ORDER FOR MODIFICATION OF LICENSE

SAFETY EVALUATION OF MECHANICAL PLUGS TO BE INSERTED INTO THE BYPASS

HOLES OF THE VERMONT YANKEE NUCLEAR POWER PLANT

**SAFETY EVALUATION OF MECHANICAL PLUGS TO BE
INSERTED INTO THE BYPASS HOLES
OF THE DUANE ARNOLD ENERGY CENTER REACTOR**

Figure 1. Plug Installed in Core Plate

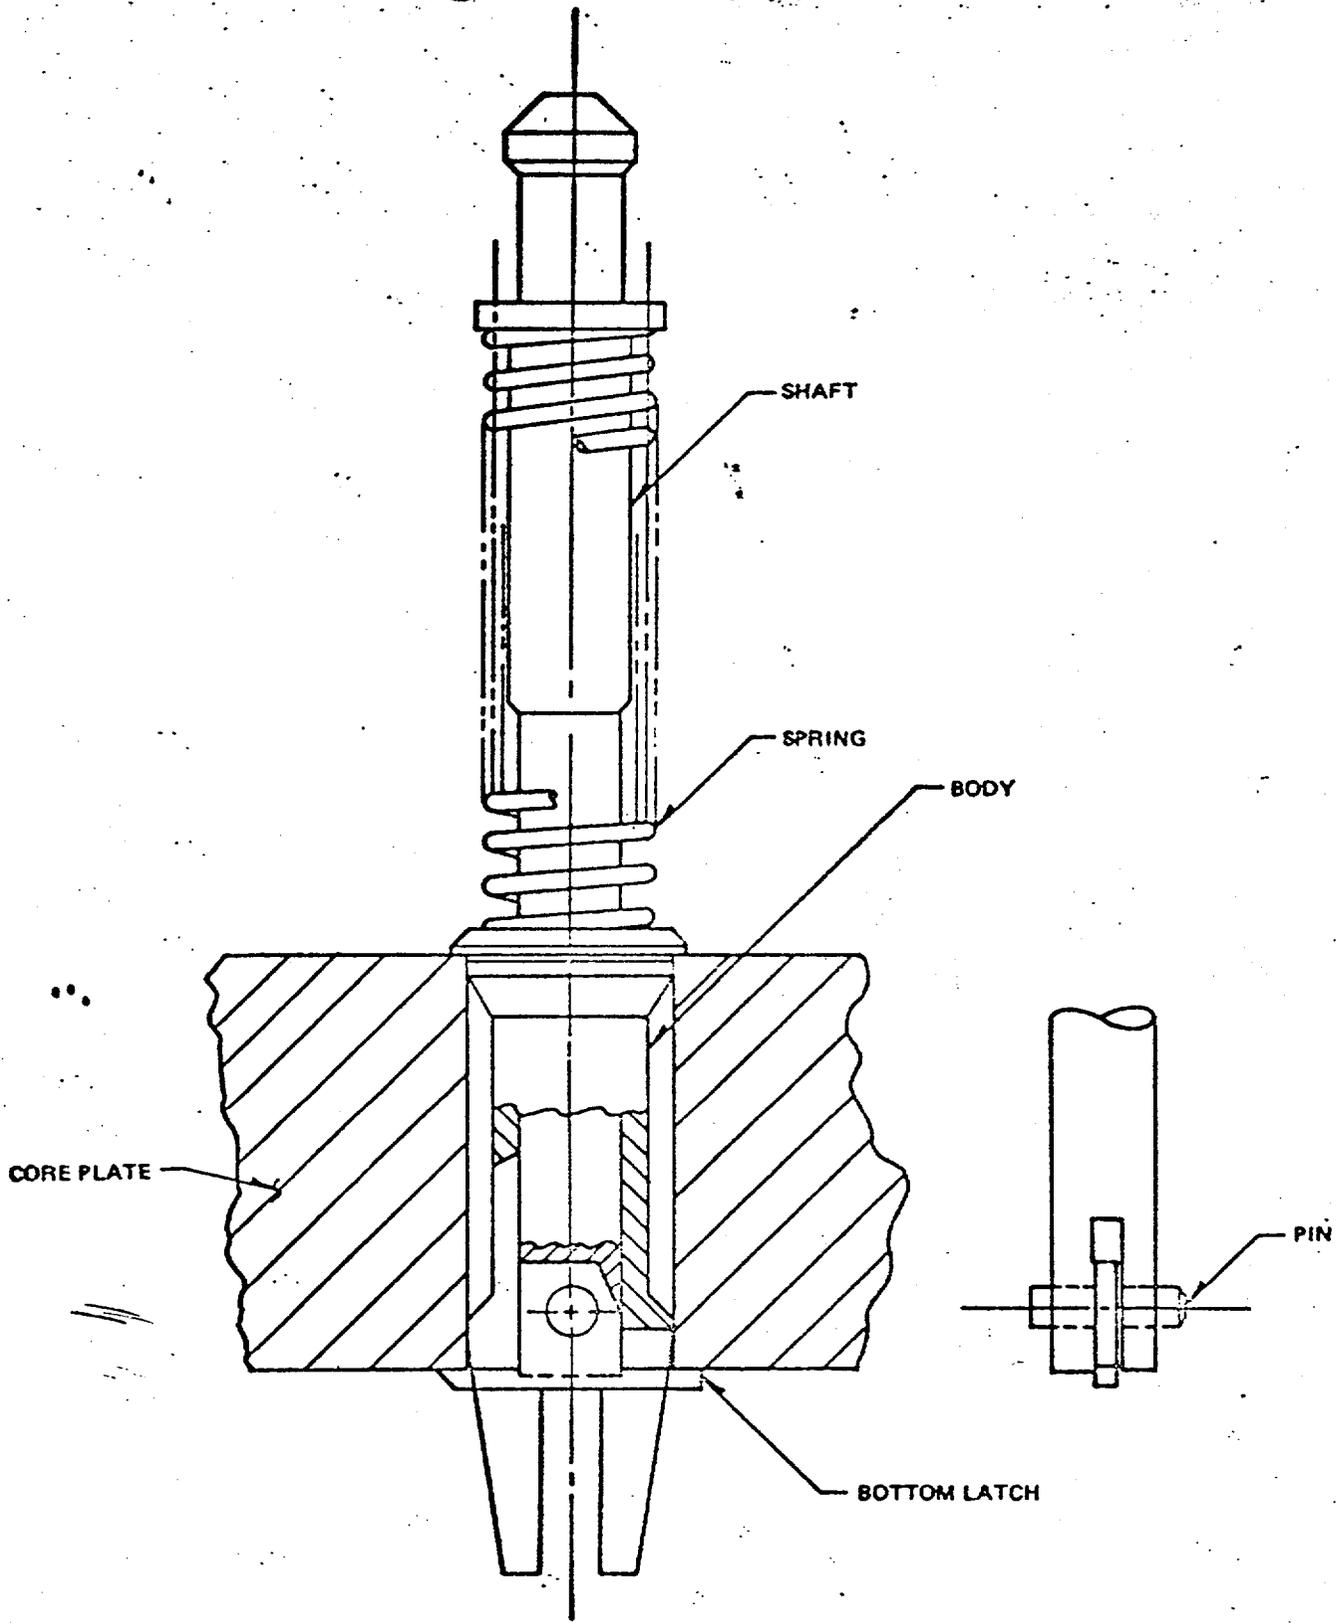
The plug consists of five basic parts, as shown in Figure 1. Identical plugs have previously been installed at Vermont Yankee, Pilgrim, and Duane Arnold. The body provides a means of guiding the device into the bypass flow holes as well as a shoulder to support the plug and form a seal against water flow. The shaft extends through the body. A knob is provided at the top of the shaft to provide a means of grabbing the plug during installation and extraction. At the bottom, the latch is attached to the shaft by a pin. The latch is free to rotate during installation. The spring acts against the body and shaft during normal operation to provide the force necessary to offset the pressure differential acting on the body.

During installation, the plug has its latch rotated 90 degrees from its installed position and withdrawn and locked in the body. The shaft is gripped by the installation tool, and the plug is inserted into the bypass flow holes. The body engages the rim of the hole. The shaft is pushed to its full extension, thus lowering and unlocking the latch below the underside of the core plate. The latch then rotates 90 degrees and bears on the bottom of the core plate. After insertion, the plug is pulled with about 30-pound force to test the placement.

The plug can be removed by gripping the top of the shaft with an extracting tool and applying a force of about 500 pounds. The latch's legs will be plastically deformed and the entire plug withdrawn. The plugs previously installed at Vermont Yankee were removed with no abnormalities or loose pieces reported. The force required for removal varied from 500 to 1300 pounds

Based on a review of the design, the test rig, the installation methods and the previously successful operating experience at Vermont Yankee, Pilgrim, and Duane Arnold, we conclude that the plugs will not fail so as to result in loose parts in the core or result in unplugging of the bypass flow holes. Also, we conclude that the installed plugs will preclude unacceptable channel box damage for at least the proposed fuel cycle. Surveillance programs will be required to confirm the nature and extent of any residual tube excitation and resultant effect, if any, on core components.

Accordingly, we conclude that the installation of the plugs should be authorized. The licensee's safety analysis for operation with plugged bypass holes, submitted July 30, 1975 is still under review.
